SHEET		1		OF		1	
MESA TOPS AT RIDGEGATE		ENTRANCE ROAD ALT A — W/O WALLS					
JOB NO.		15950.12

MESA TOPS AT RIDGEGATE
ENTRANCE ROAD ALT B
WI WALLS

PRELIMINARY ROAD REDESIGN
ALTERNATIVE 1
MESA TOPS – CABELA DRIVE
1595018
10/28/2024
SHEET 1 OF 2

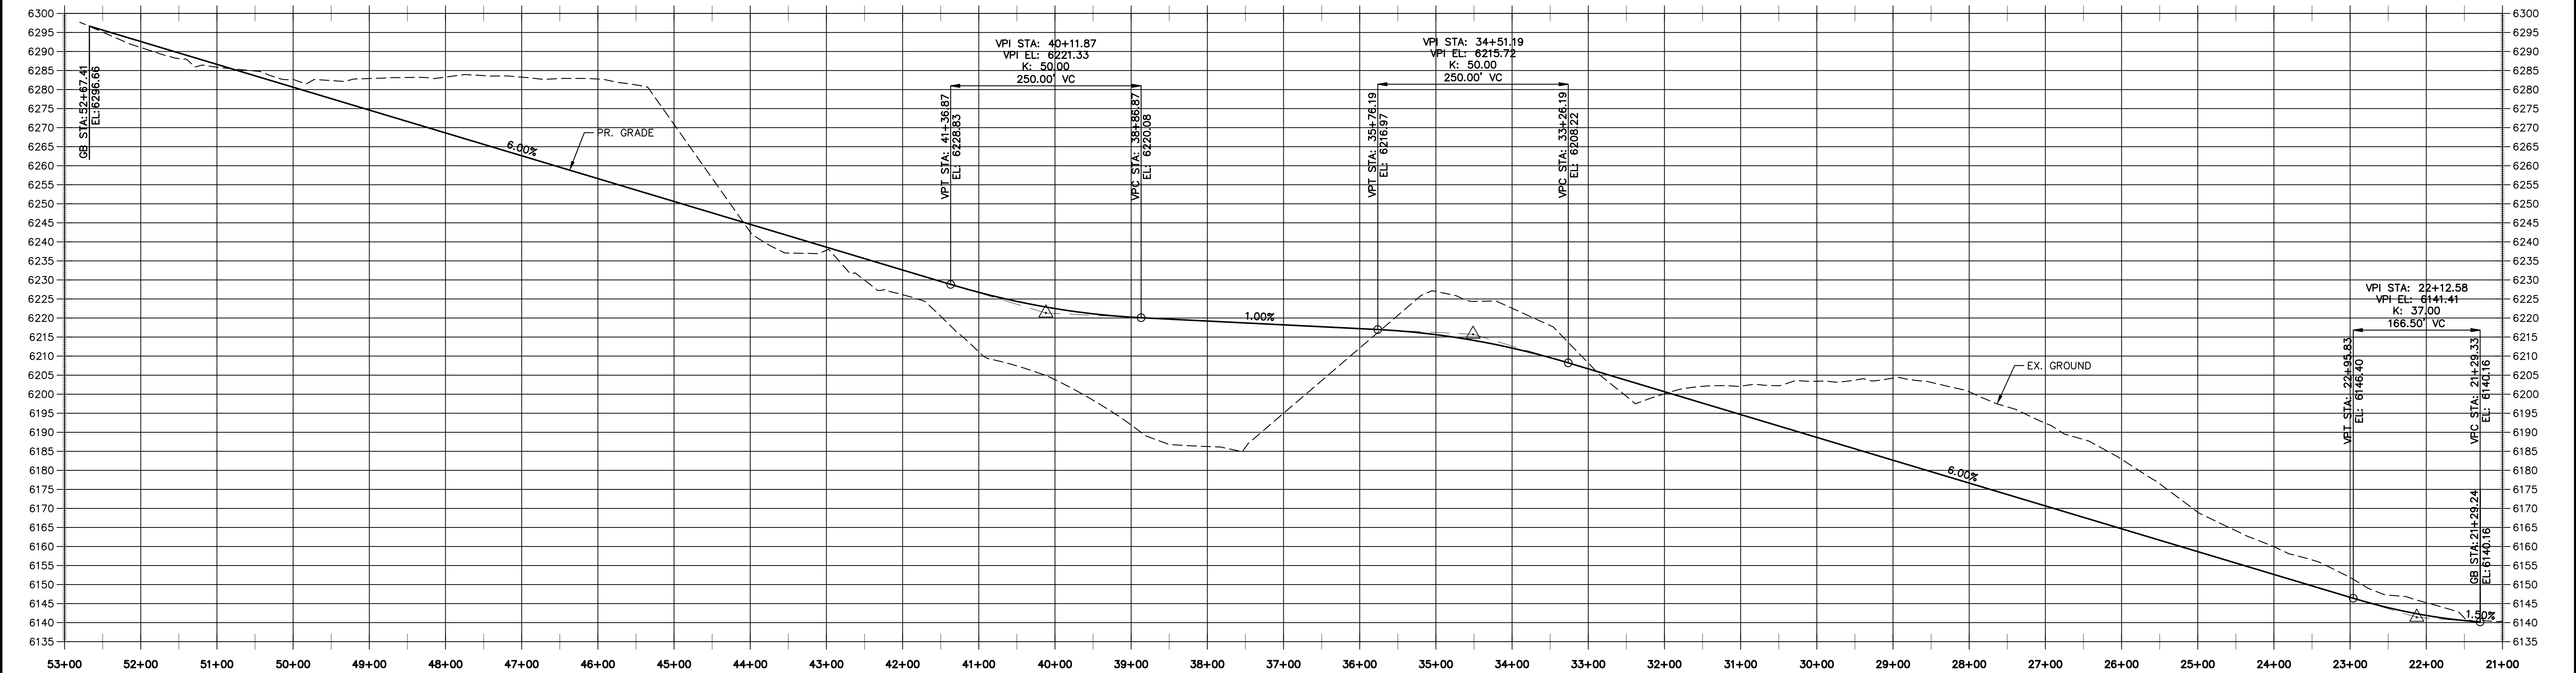
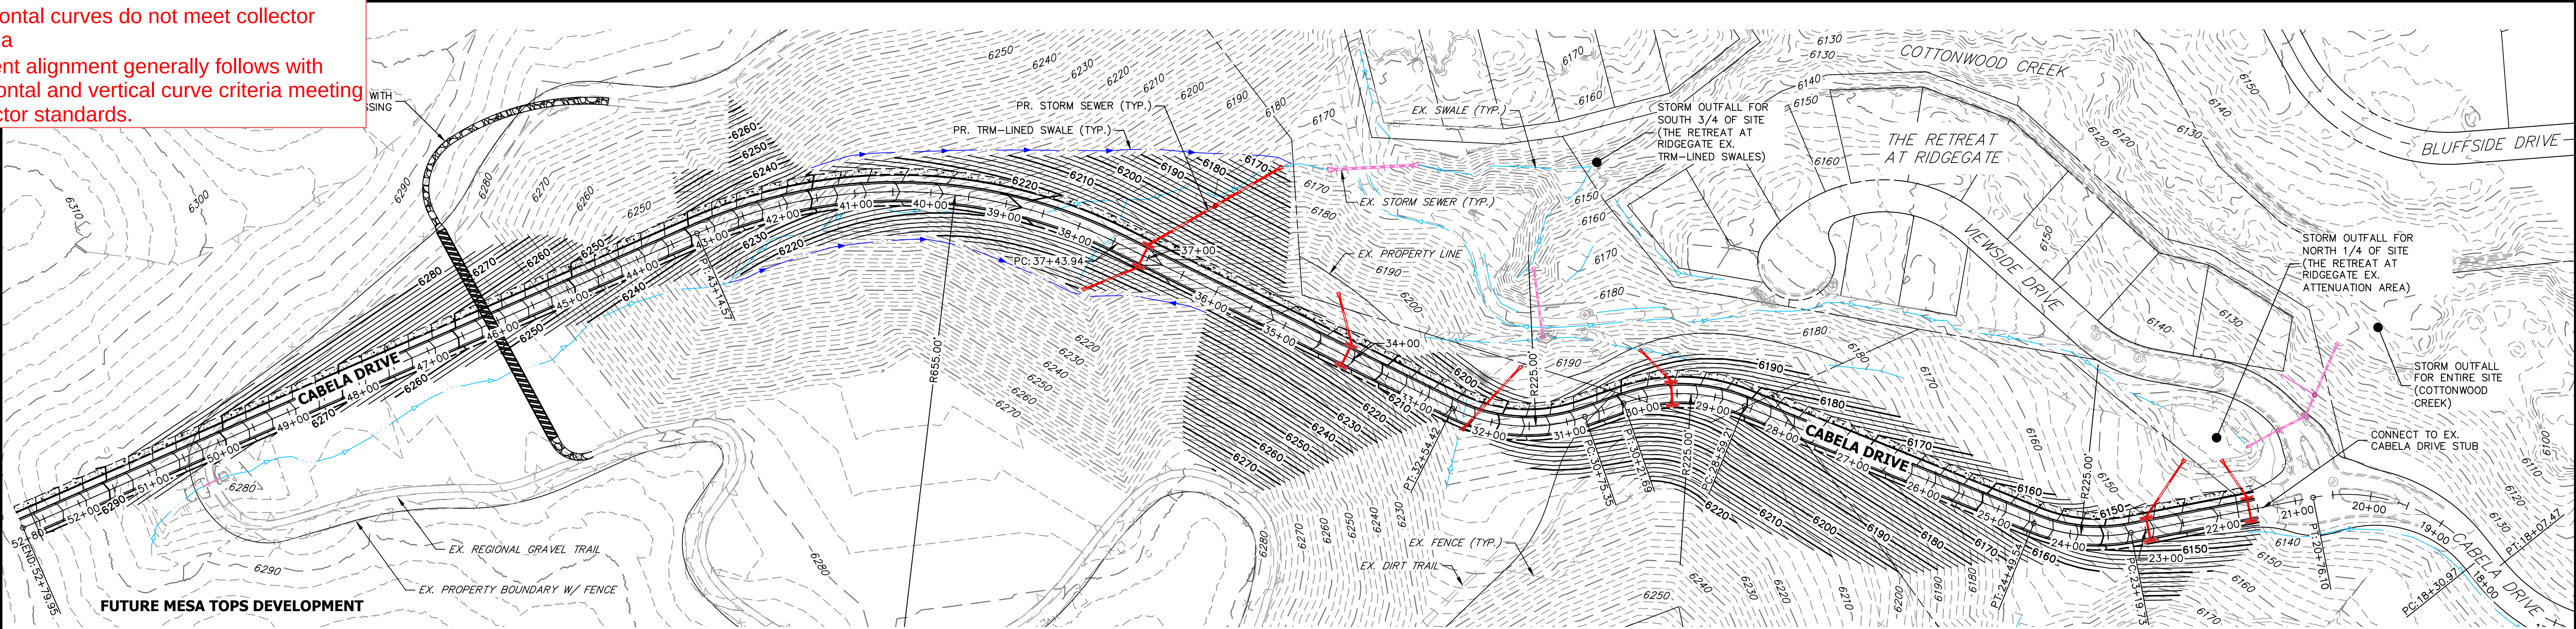
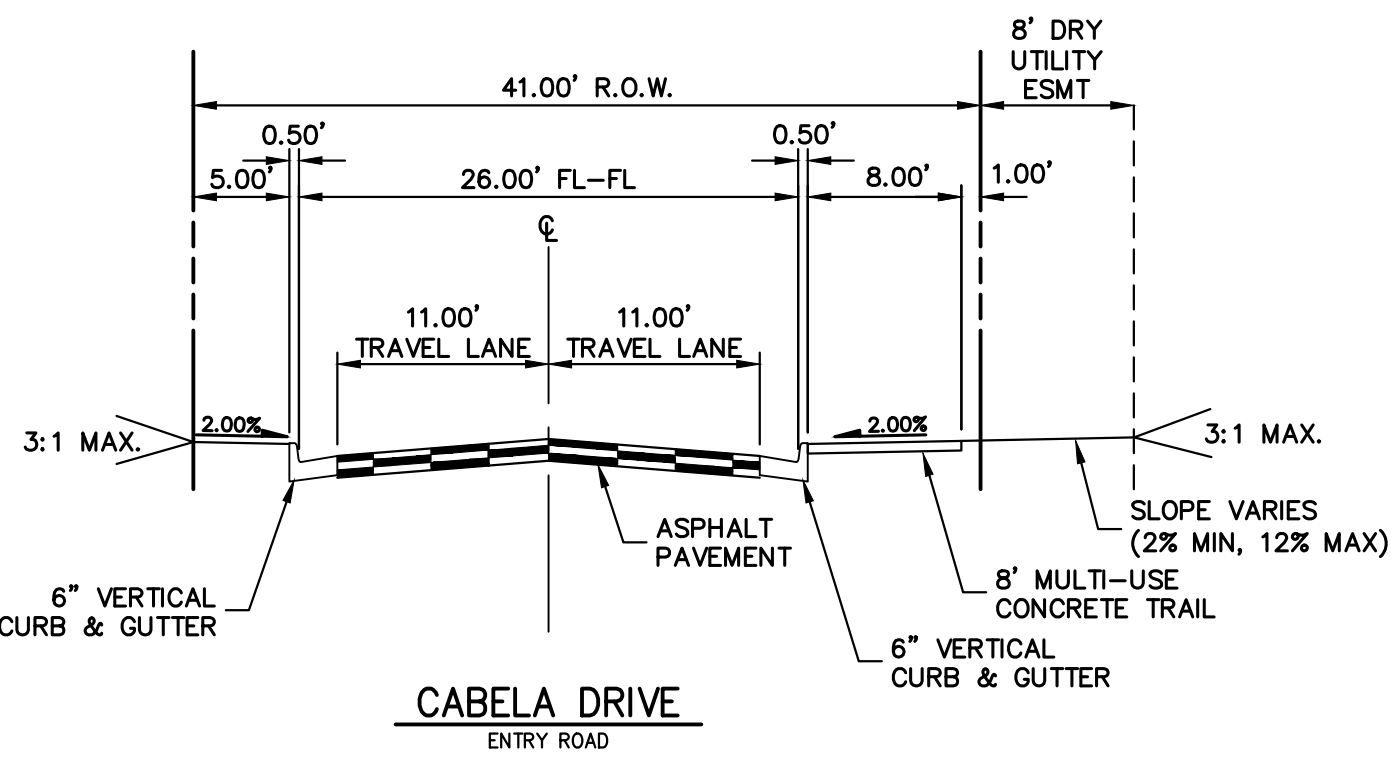
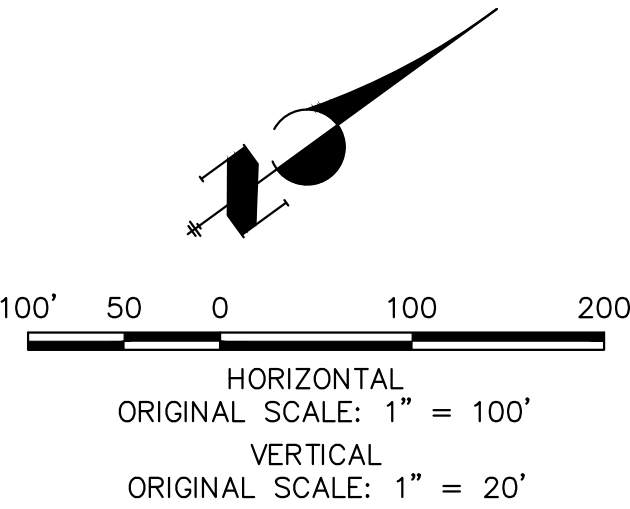
- Option not selected -
- Horizontal curves do not meet collector criteria
 - Current alignment generally follows with horizontal and vertical curve criteria meeting collector standards.

PRELIMINARY ROAD REDESIGN
ALTERNATIVE 2
MESA TOPS - CABELA DRIVE
1595018
10/28/2024
SHEET 2 OF 2

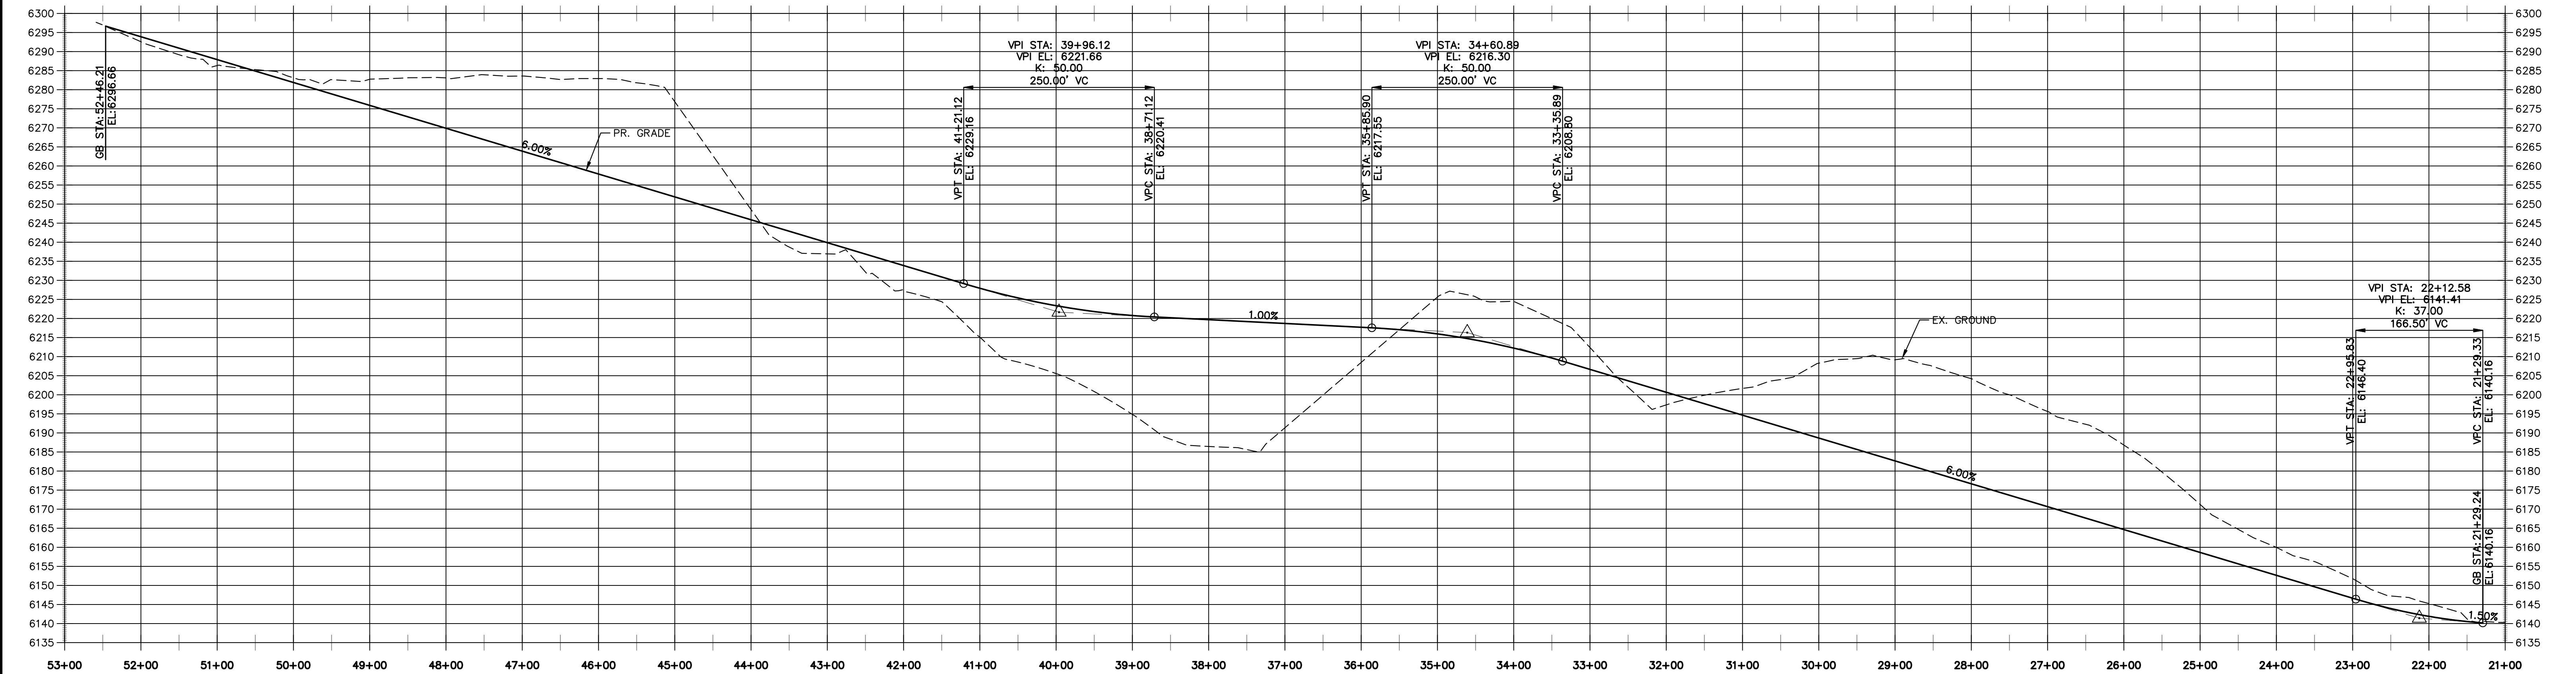
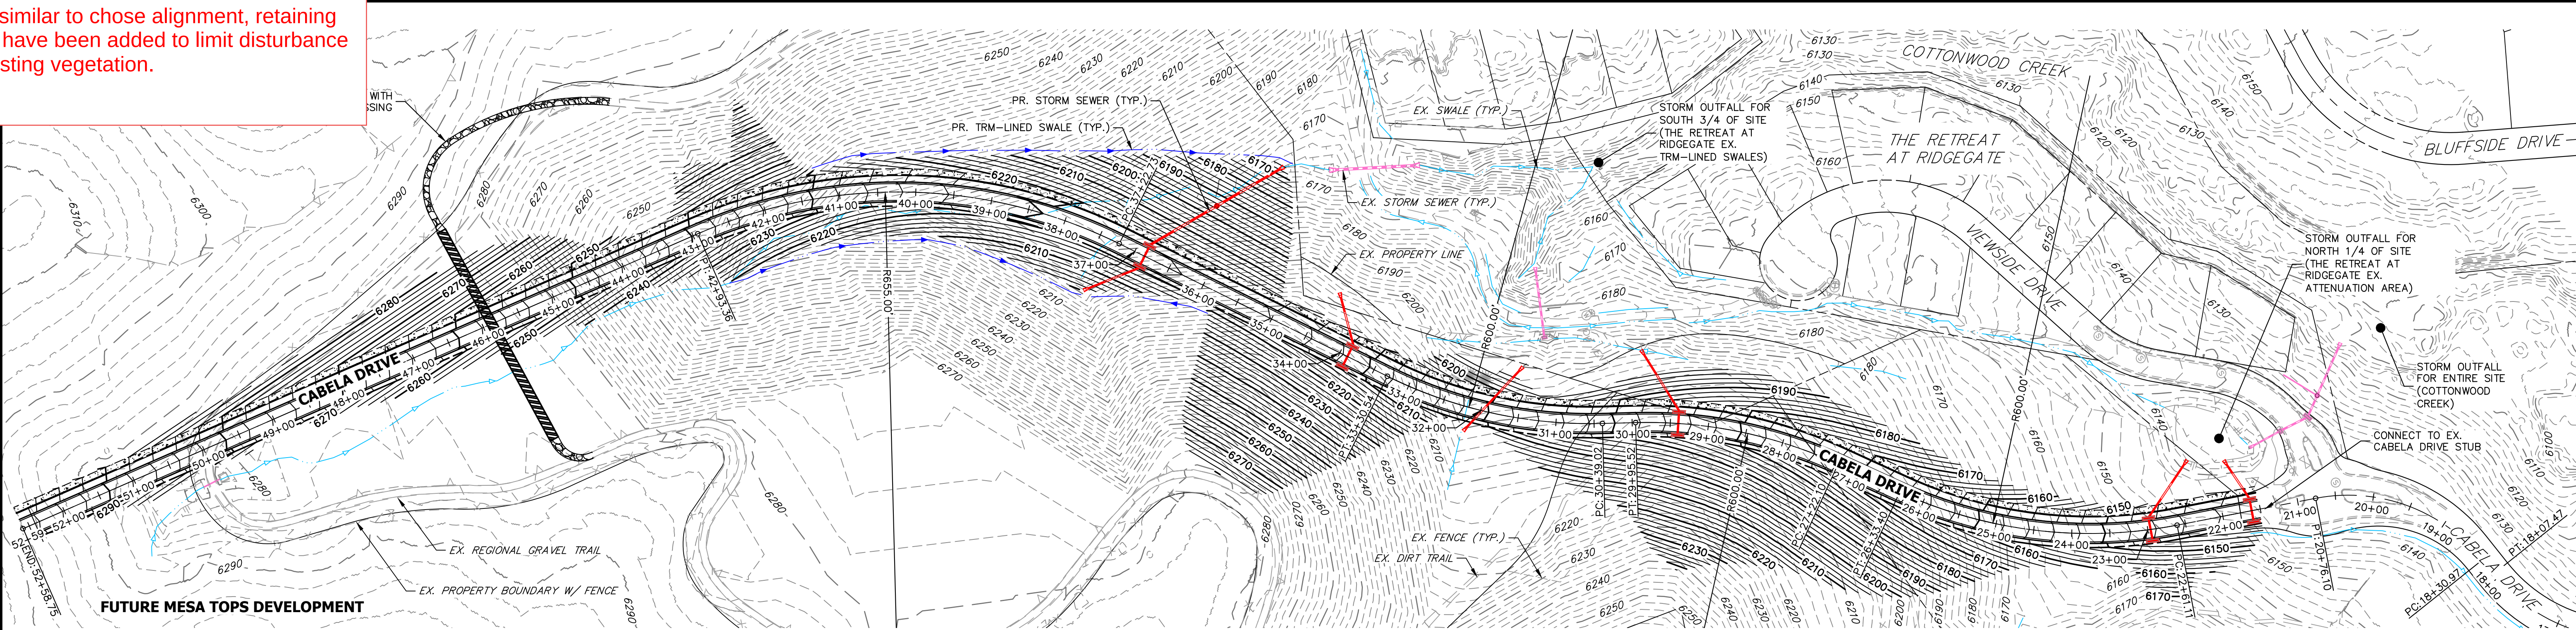
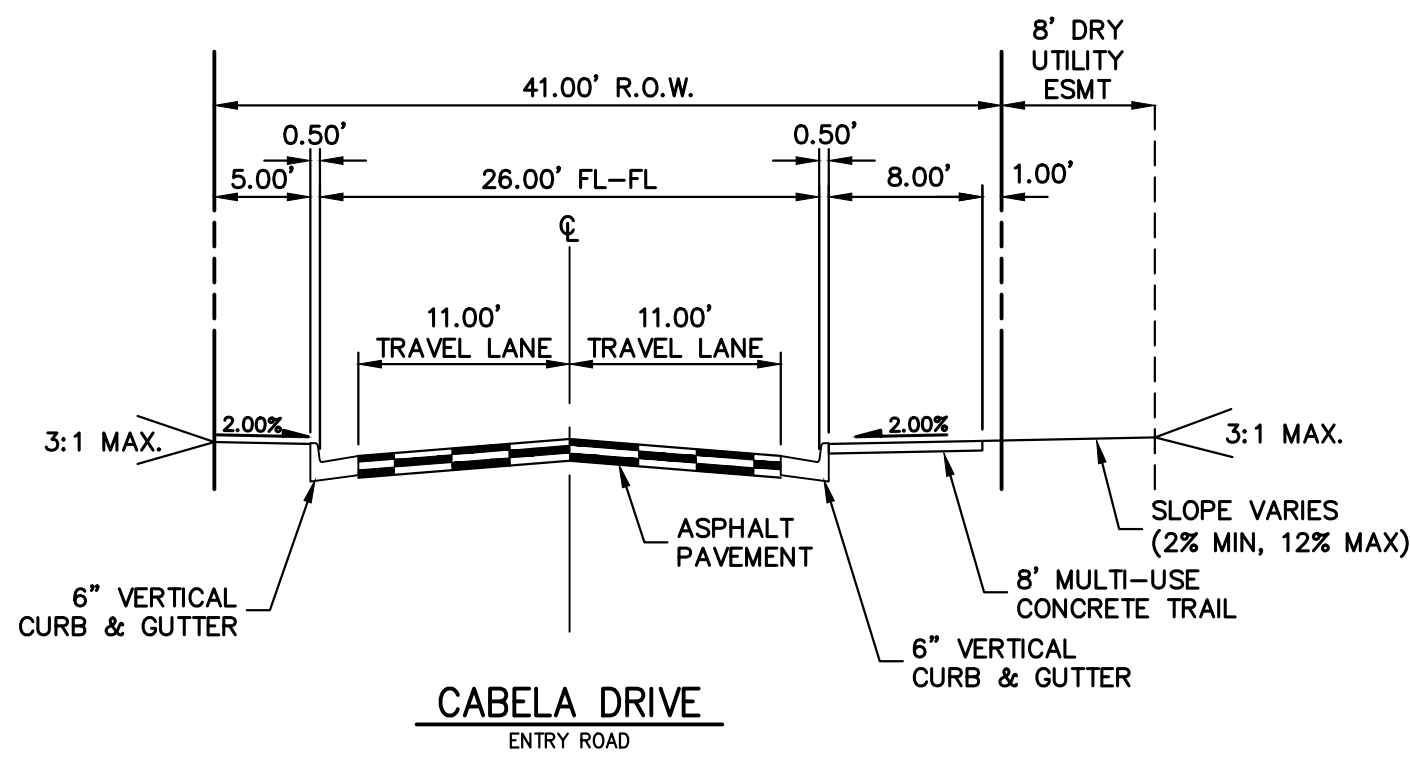
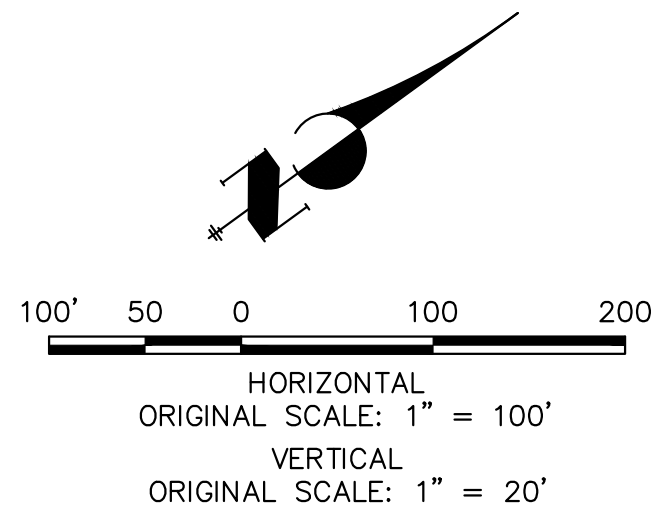
- Option not selected -
- Very similar to chose alignment, retaining walls have been added to limit disturbance to existing vegetation.
